Development of Draft Construction Safety Standards for Excavations

Volume II

DEVELOPMENT OF DRAFT CONSTRUCTION SAFETY STANDARDS FOR EXCAVATIONS

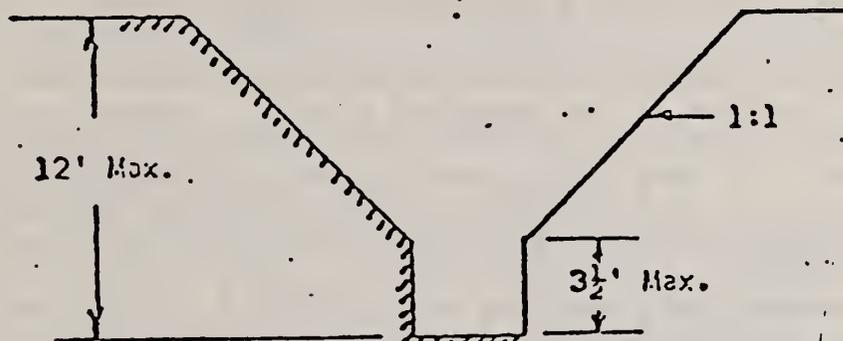
(5) Allowable Slopes: California AGC suggested that the compound slope case shown in Figure 2, Case IV should be limited to 12 ft. depth in hard compact soils (California definition) and shown as in the California Standard. It was also noted that a California study shows that the bank next to the work area in Case III would be safe at 4 ft. depth. I have no problems with these suggestions (except that we do not have the California "hard compact" category), except perhaps that they may be too restrictive. They are based on a study by R. T. Frankian and Assoc. (see Attachment). The concept used in this study was that of equivalency to an unsupported 5 ft. deep vertical bank. Such a bank would "just stand up" in a very soft clay with cohesive strength of only 150 pcf - a very soft soil indeed, which is only rarely encountered. For such a soil, if it can be sloped at all, our allowable slope would be only 1-1/2 to 1, a very flat slope. Our proposed compound slopes in Figure 2 are based on a somewhat different set of assumptions: equivalent stability to a sloped trench for whatever the depth of the trench happens to be. Of course many of our Type B soils will not stand with an unsupported bank of any depth, since they would be "running" by the California Standard.

Figure 4. Components of the Shoring System

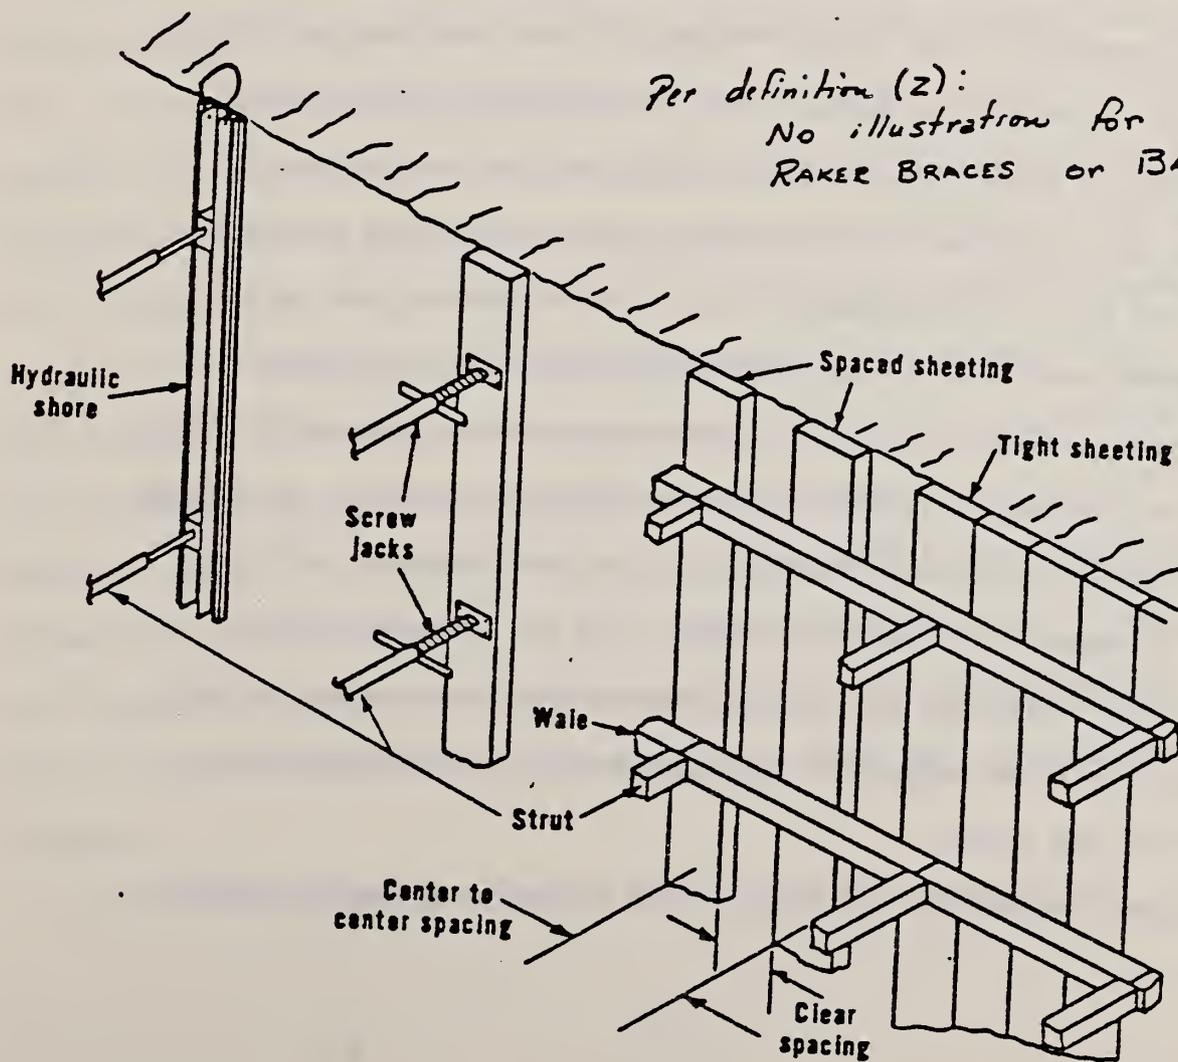
- ✓ (w) Spaced Sheeting is sheeting in which the members bearing against the excavation wall are spaced (see Figure 6). *Figure 4?*
- ✓ (x) Spalling is the continuous flaking and falling of soil or rock from an unsupported trench wall.

- ✓ (y) Standard Practice is the trenching and shoring practice in Section 1926.652 (b).
- ✓ (z) Struts are the primary support members of a shoring system including but not limited to cross braces, raker braces, jacks and backties (see Figure 6) *Figure 4?*

Raker braces or backties are not illustrated
